# LASER INTERFEROMETER GRAVITATIONAL WAVE OBSERVATORY

Document Type	DCC Number	Nov. 16th, 2016
Test Procedure	T1600542-v1	
<b>TCS Laser Chiller Chassis Gain Revisions</b>		
B. Abbott

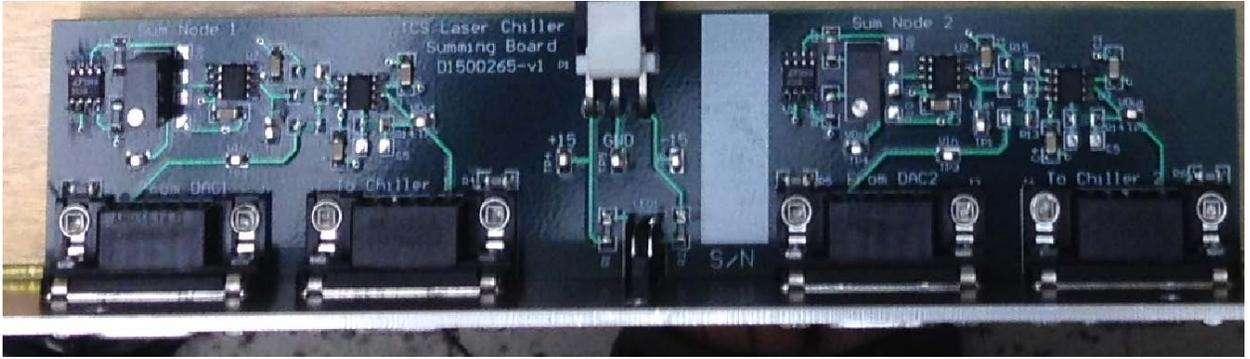
Pin 6 removal to stop grounding the negative DAC leg:

With a pair of needle-nosed pliers, forcibly extract pin 6 from the “From X-Arm DAC”, and “From Y-Arm DAC” connectors on the front of the TCS Laser Chiller Summing Chassis:

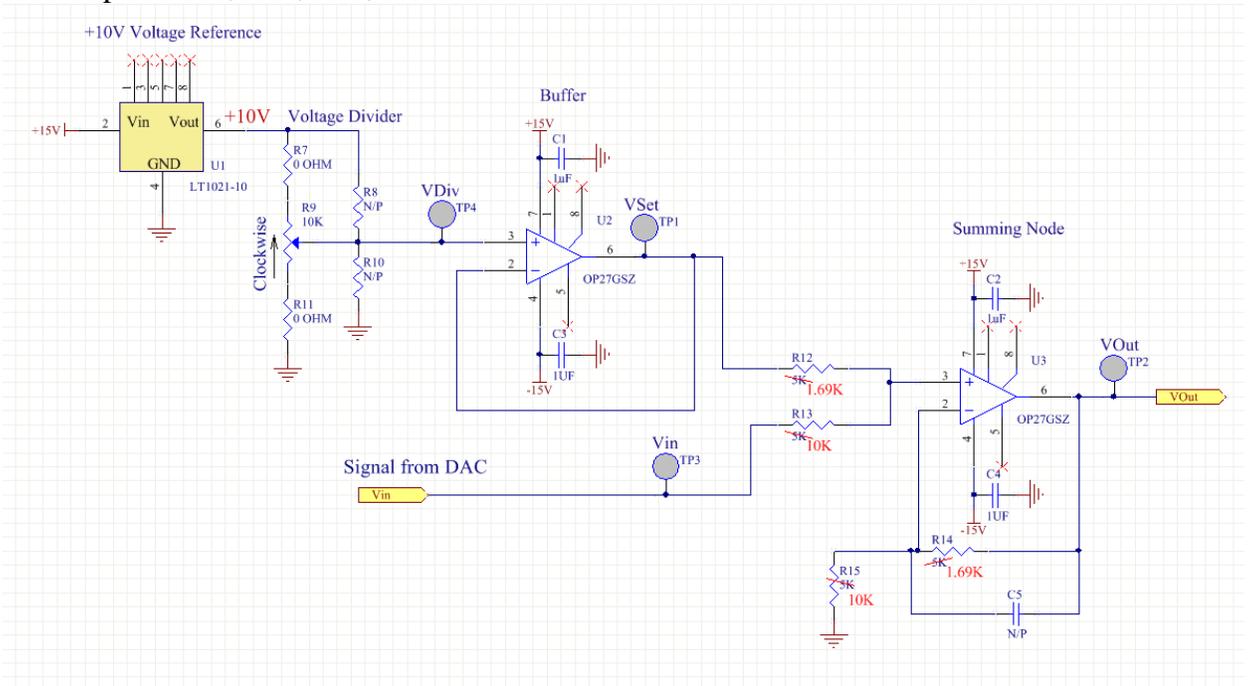
Discard the pin and remove the front panel, to expose the internal board:

Four resistors need to be changed for each chiller (8 resistors total), to reduce the gain of the DAC path: R12, R13, R14, and R15. Here are the new values:

Example part numbers from Digikey are: (1.69K) P1.69KBCCT-ND and (10K) TNP10.0KACCT-ND.

Re-assemble the chassis, and check that the gain of the DAC path is 0.17V/V.
